Group:	SERVICE MANUAL UPDATE
Bulletin No:	SB-15-034
Issue Date:	8-12-2015

## Subject: CORRECTION OF WORKSHOP MANUAL FOR HINO COE Revision of Troubleshooting Procedure for the DTC P0A84 (TC66)

**RELEVANT MODEL:** 14MY-15MY Hino 155, 195, 155h, 195h

Troubleshooting information and inspection procedure of the DTC P0A84 (TC66) were revised.

## 8 Inspecting the voltage of PCU wire harness (upper side)

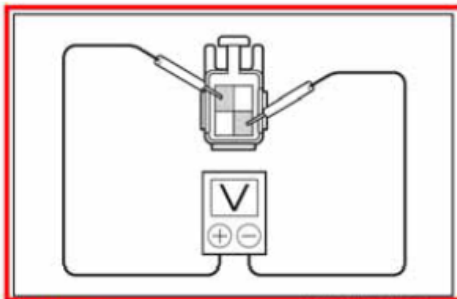
CHANGE

- Set the starter key to the "LOCK" position.
- Connect all the connectors that have been disconnected.
- Disconnect the connector of HV battery cooling fan.
- Set the starter key to the "ON" position.
- Using the electrical tester, measure the voltage between the connector terminals of HV battery cooling fan.

Measurement conditions	Tester connections	Standard values
Starter key: ON CHANGE	HV battery cooling fan connector 1st terminal – 4th terminal	9 V or more
